RAI Responses

CHAPTER 1 GENERAL INFORMATION

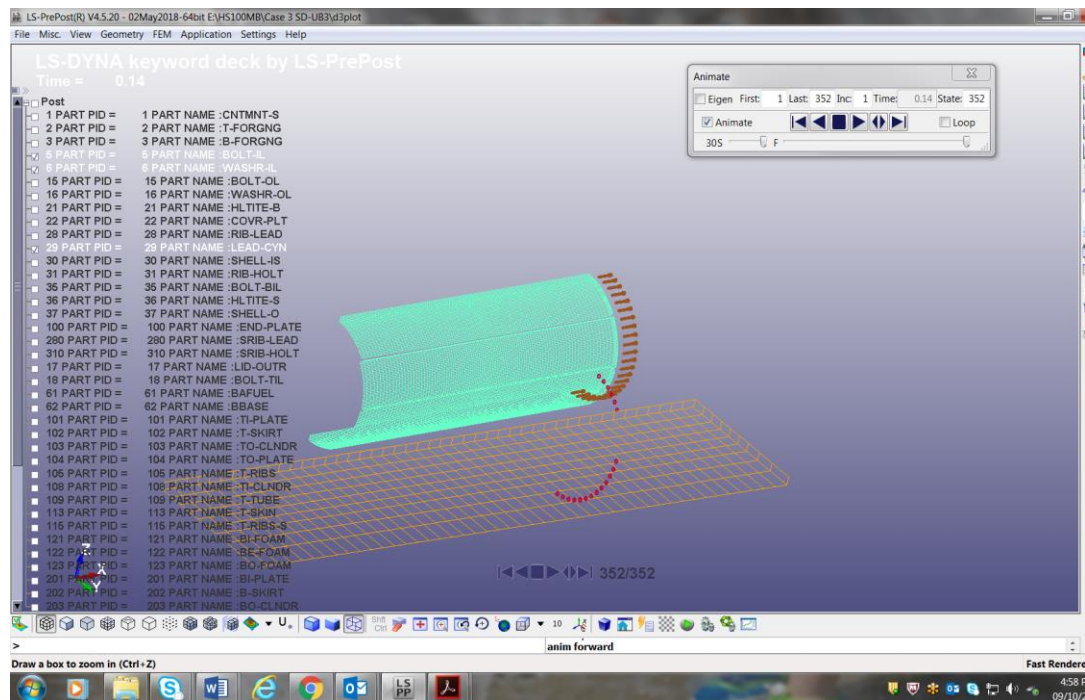
The LS-DYNA results of Case 3 SD-UB3 (portrayed below), show that, at some point during the drop simulation, the inner lid washers (LS-DYNA 6 Part PID = 6 Part Name Washr-IL) seem to move separately from the bolts. It is not clear to the staff if this situation is realistic, and if containment can be maintained. The following needs to be addressed:

- a. Clarify if the observed behavior is in fact expected and, if so, describe how the containment boundary is maintained with the absence of the washers.
- b. If the observed behavior is not expected, revise the model for this and all simulated drop scenarios, as appropriate.

The slapdown analysis (Case 3 SD-UB3) is performed for the governing XL version of the HI-STAR 100MB cask, which is used to transport a loaded MPC so only the outer closure lid is needed. Therefore, the inner lid is removed from the LS-DYNA model of the Version XL package. The inner lid bolts and inner lid bolt washers were unintentionally left in the model, but not included in any of the contact definition. Since they do not interact with the rest of the package in the LS-DYNA model, their presence in the slapdown analysis model has no affect on the analysis results. Thus, the loose inner lid washers identified by the reviewer are of no concern and are not an indication a containment breach. Identical results would be obtained if the simulation were repeated after removing the inner lid washers from the model.
